**NEW HOPE**  
GROUP

## 6. Errata

#### NEW ACLAND COAL MINE STAGE 3 PROJECT

**Figure 4-7b - Pre revised Project Land  
Suitability – Dryland Cropping  
Mining Area**

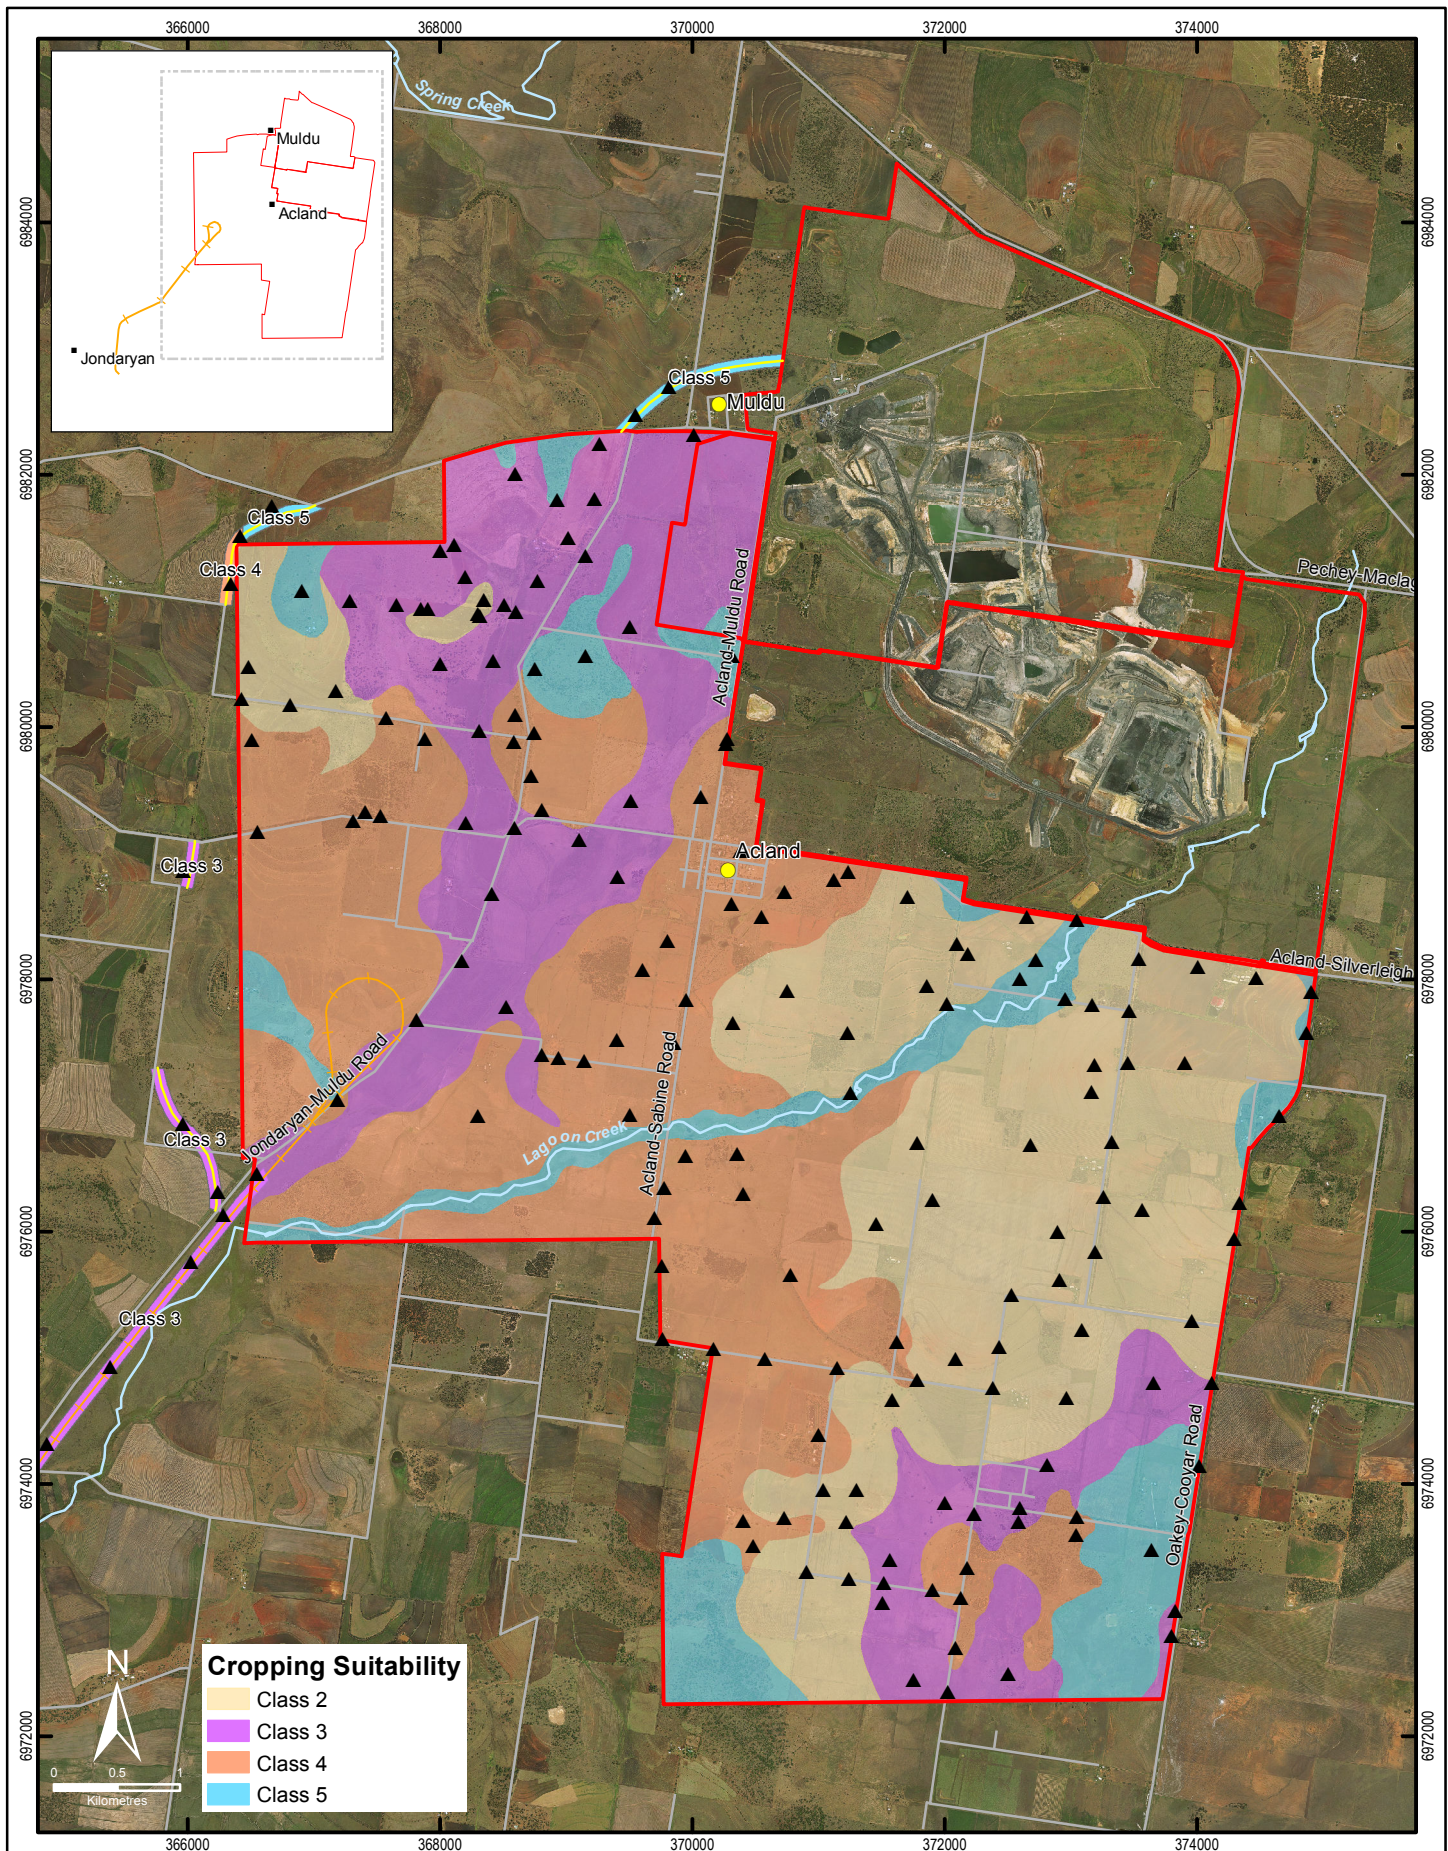
- **Figure 4-7B** of the draft EIS has been updated, and is presented in below.
- The statement in **Section 4.8.3**, page 4-68 of the draft EIS should read:

**Figure 6.4-A Annual Controlled Release Volume**

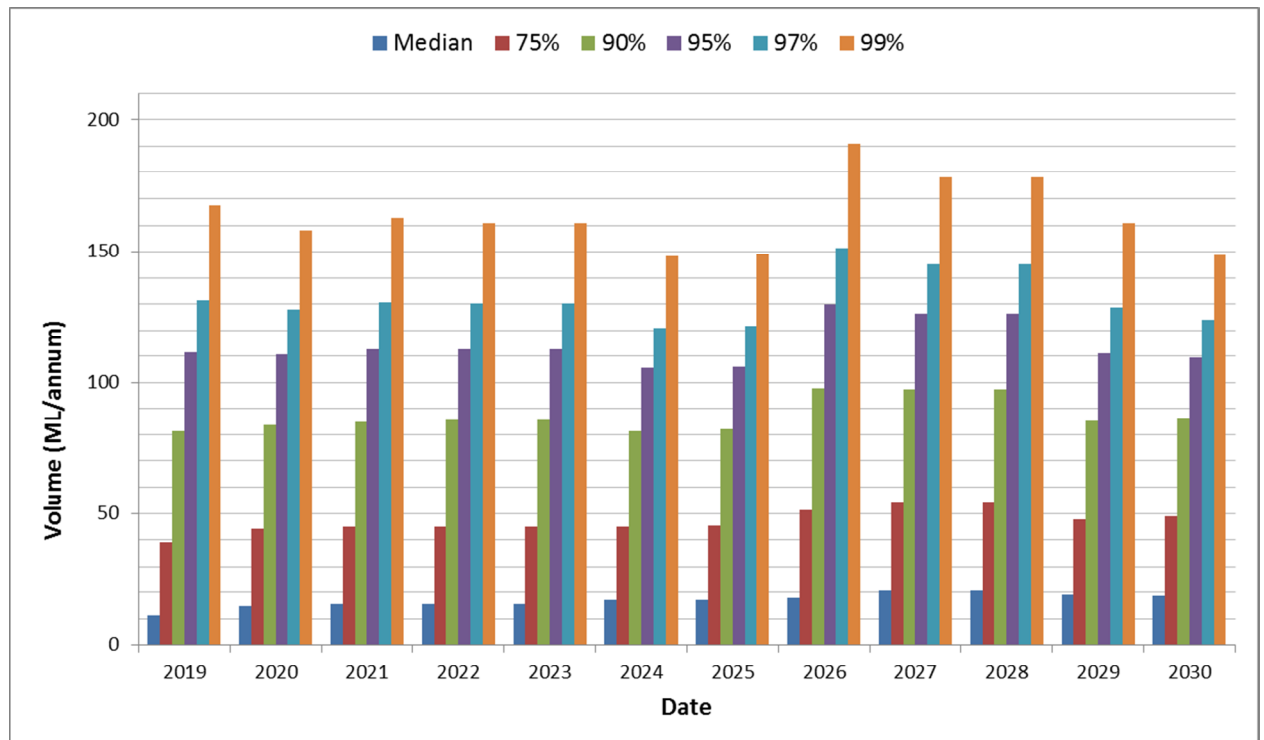
- It is noted that the annual controlled release volume presented in **Figure 5-35** of **Chapter 5** of the draft EIS and **Figure 5-3** of the Water Resource Management Plan (**Appendix J.4** of the draft EIS) presents the total volume predicted to be released over a given year. That is at the 99<sup>th</sup> percentile of the probabilistic rainfall (very wet year) there is predicted to be 190 ML released in the year 2027. An updated chart is provided in **Figure 5.2-S** below.

- As per the above comment it is noted that there is a typographical error in the second sentence of the first paragraph on page 80 of **Chapter 5** and the sentence should read. *“The results indicate that in an average year only minor releases in the order of 20 ML/year will be made to Lagoon Creek with releases increasing to a maximum of **170** ML/year in the 1 % exceedance probability (very wet year).”*

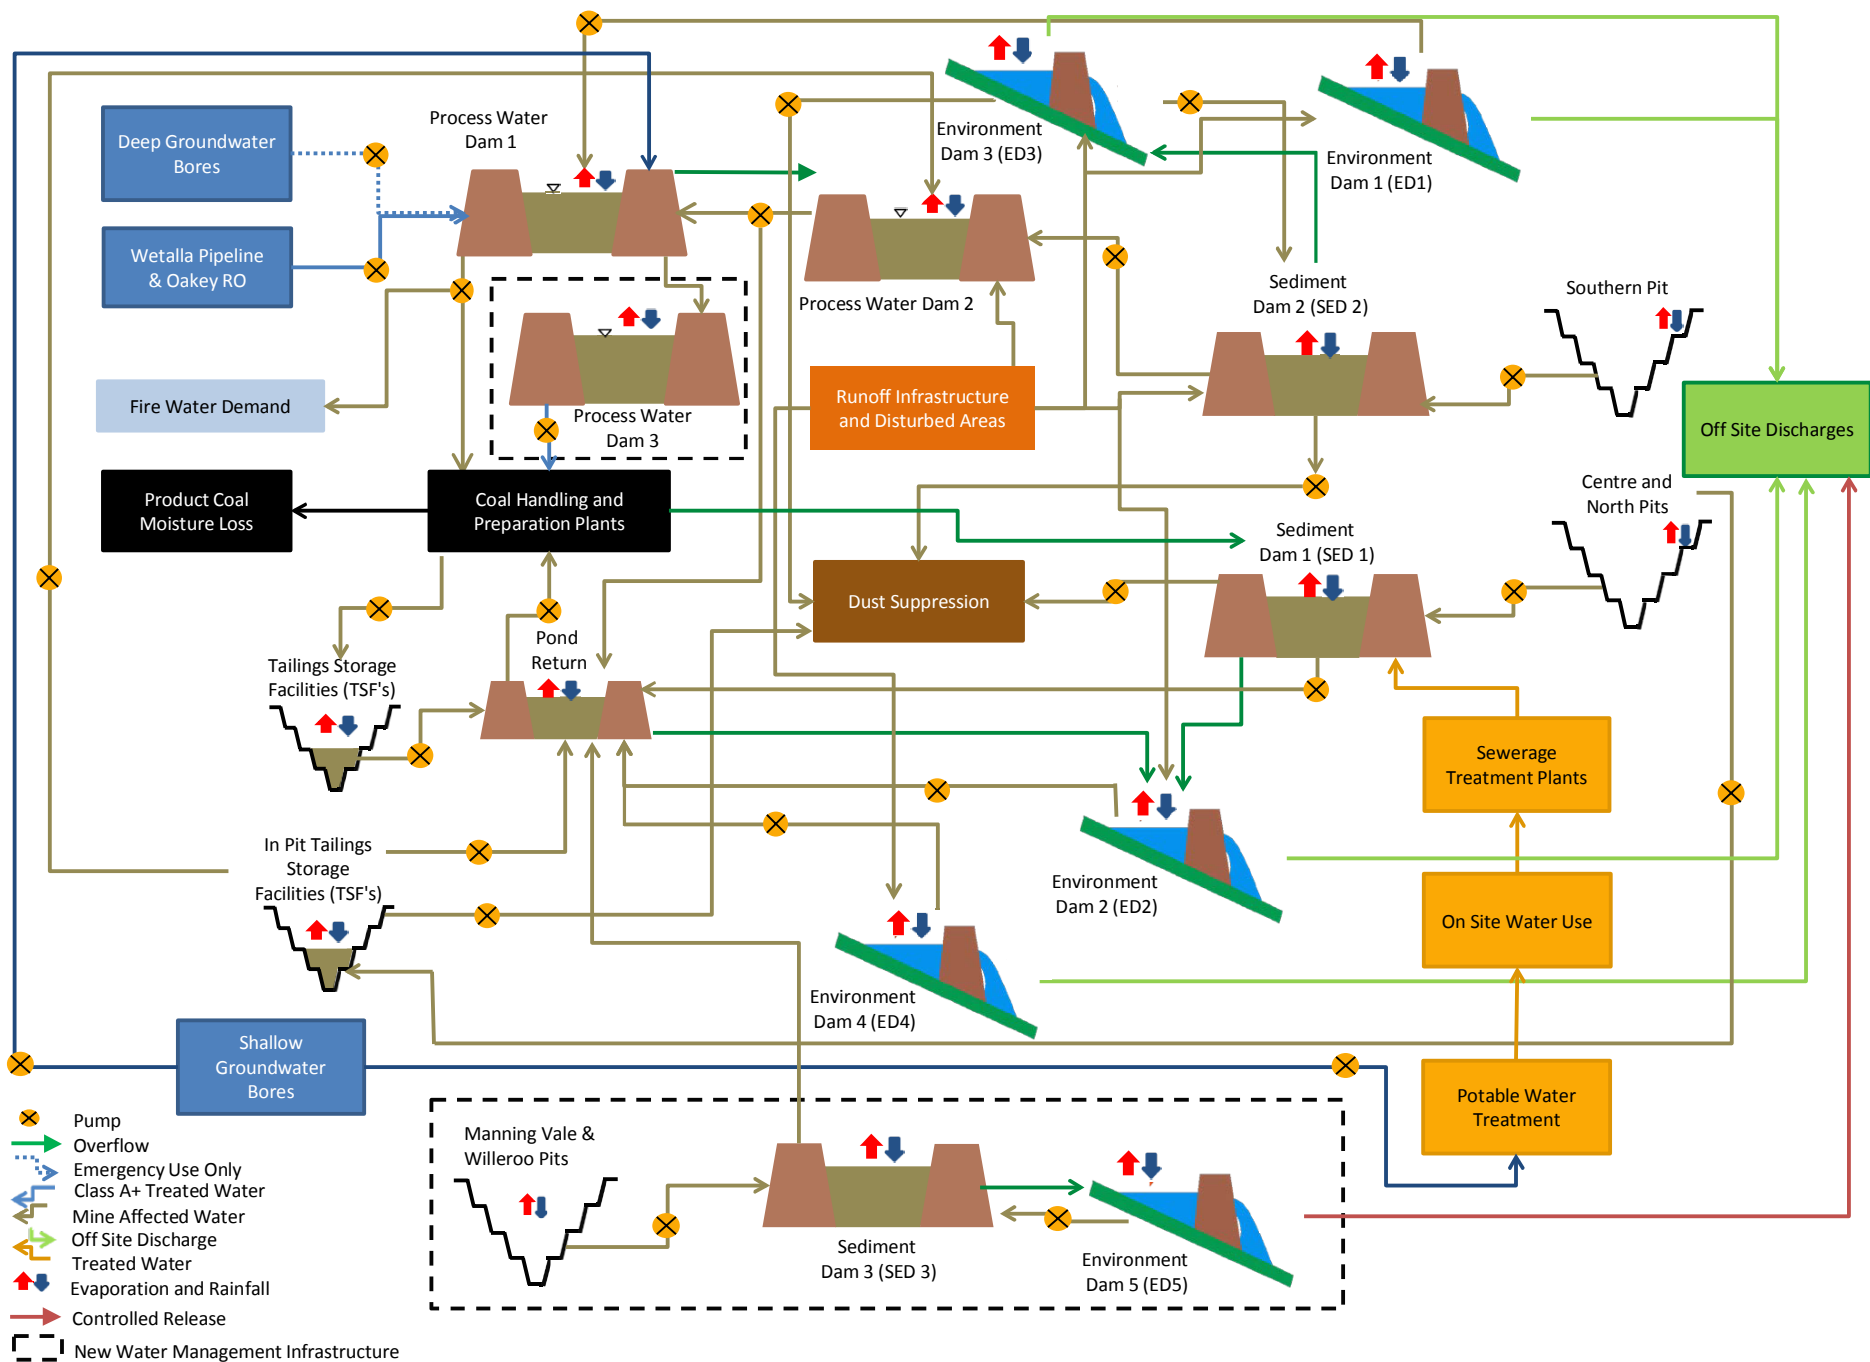
The dark orange arrows in **Figure 5-32** of the draft EIS were displayed in error as these arrows were attached to the base graphic and should have been removed. The updated Schematic is presented below.
